SPI-3 LVD Setup/Hold Time Issues

Frank Gasparik, January 25, 1998

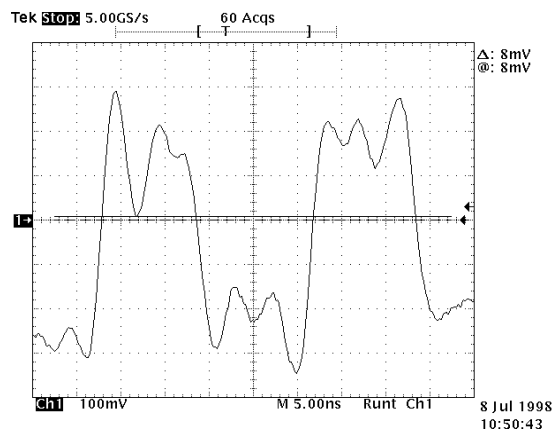
The SPI-3 document defines the LVD timing as shown in Figure 45. For both REQB and ACKB signals the “May be detected” values are 60mV before the differential zero crossing. This values are used incorrectly as the threshold for the LVD Receiver. Some LVD system users are assuming that if the signal dip (glitch) gets to this value (or to the differential zero crossing) it will result in a system integrity problem. None of the customers’ or our tests could show the LVD system failures due such dips as shown below.

This data is presented at the January 26, 1999 SPI-3 meeting in order to modify the SPI-3 Figure 45 and similar figure in SPI-2 document.

Figure 1 Glitch Width 1ns

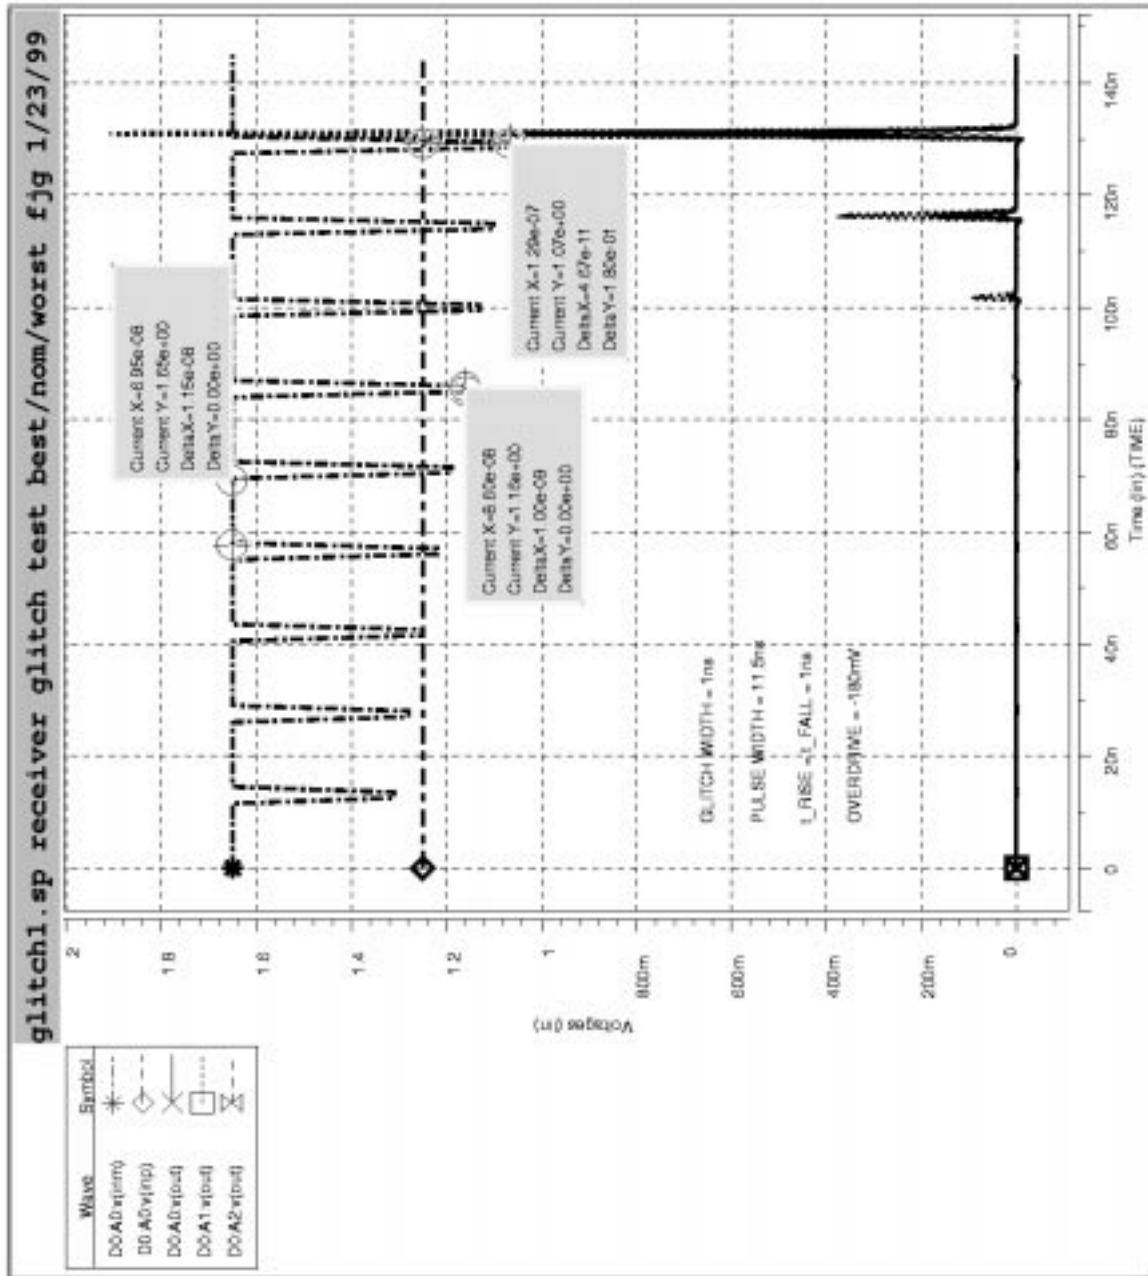
Figure 1 shows the results for the glitch 1ns wide. The receiver has to be overdriven by an amount of -180mV to propagate the signal to the output.

Figure 2 Glitch Width 2ns

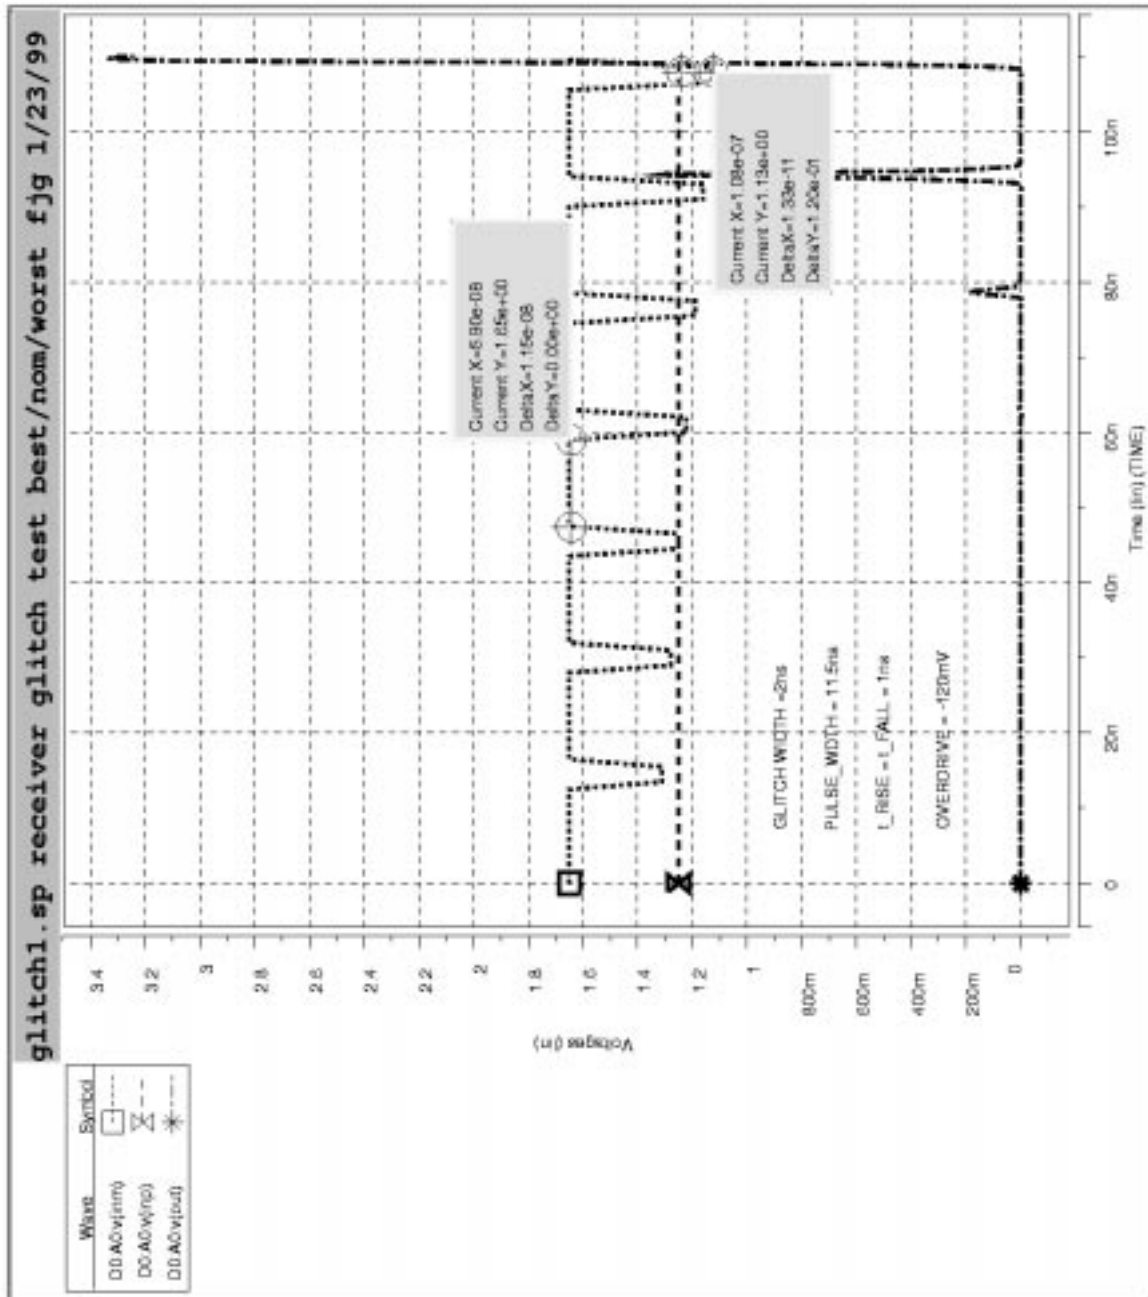
For the glitch width equal to 2ns the overdrive must be -120mV to propagate to the output as illustrated in Figure 2.

Figure 3 Glitch Width 3ns

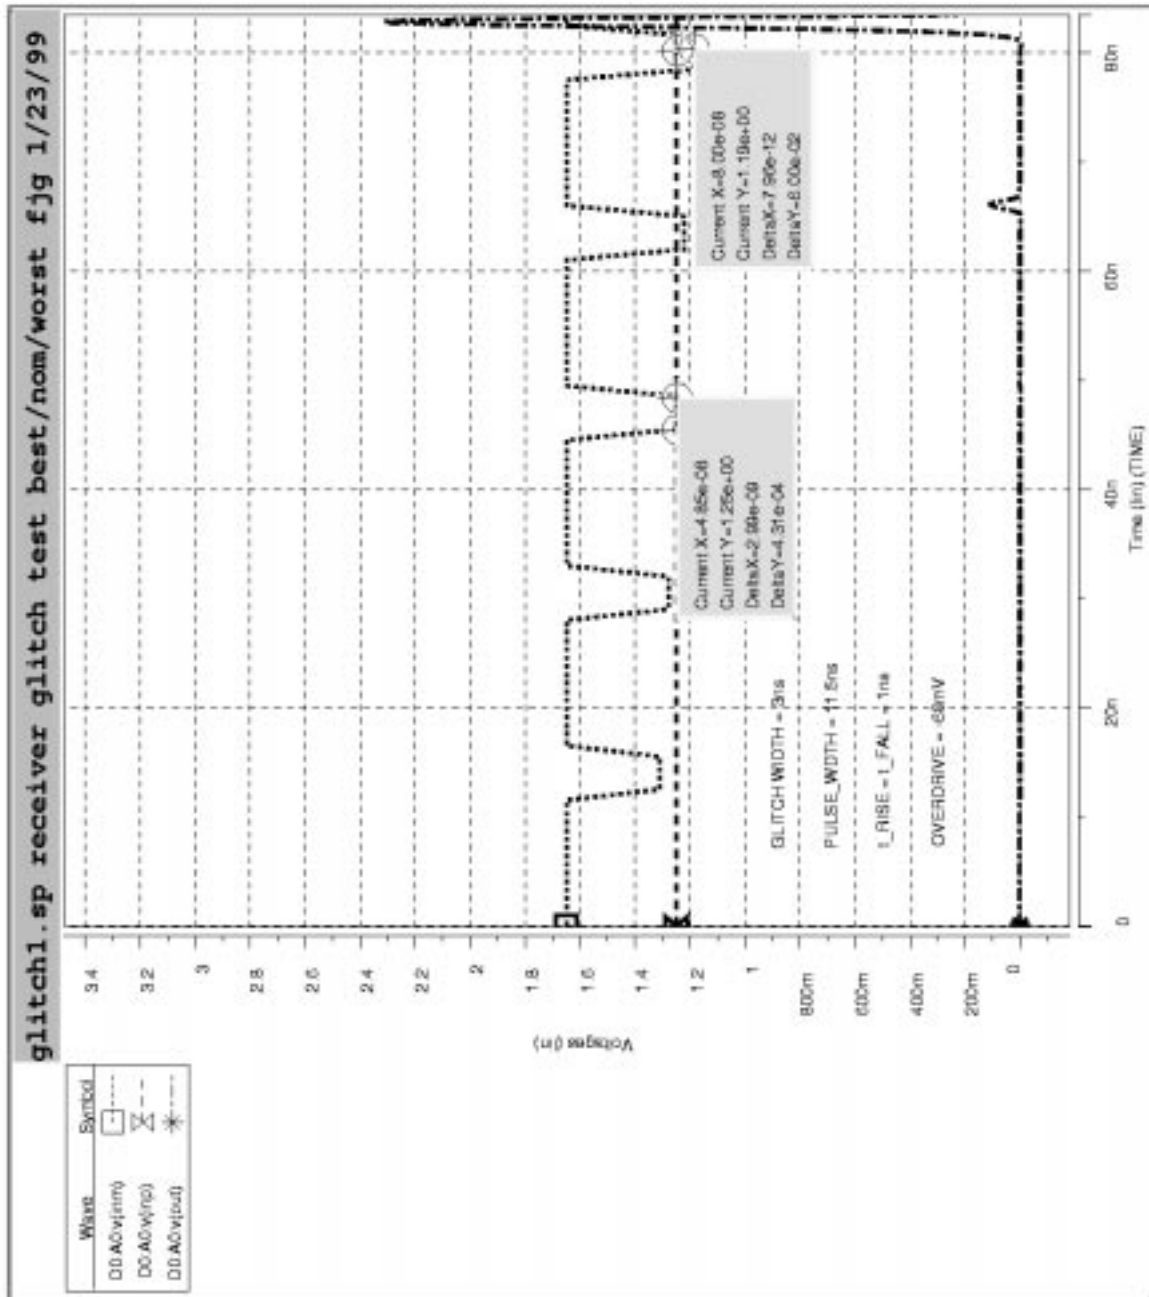
Similarly, Figure 3 shows the case with glitch width 3ns. The amount of the overdrive is equal to -60mV for glitch to be detected.
